Subject: REAR MUDGUARD IS WARPED CAUSING POOR APPEARANCE/NOISE	Bulletin No: 09-028/15
	Last Issued: 07/24/2015

2014-16 Mazda3 (Mexico built) vehicles with VINs starting with 3MZ

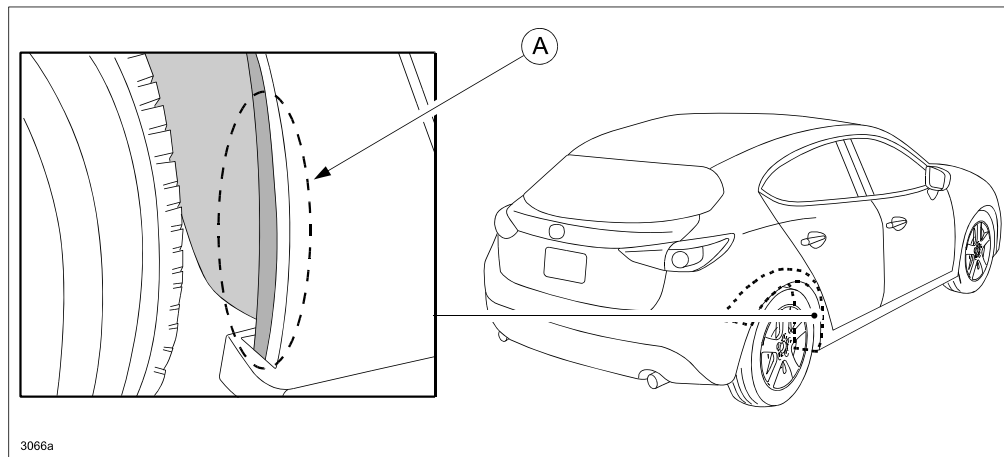
Some vehicles may exhibit a warped rear mudguard with the surface edge (A) visible from outside the vehicle, causing a poor appearance. In the worst case, it could touch the tire and cause a rubbing noise. The deformation is due to product variation.

1. Verify customer concern.
2. Replace mud guards (both sides) with ones used for Japan production Mazda3 (JM1) according to the instructions on MS3 online or the Workshop Manual (section 09-16 MUDGUARD REMOVAL/INSTALLATION).
3. Verify repair.
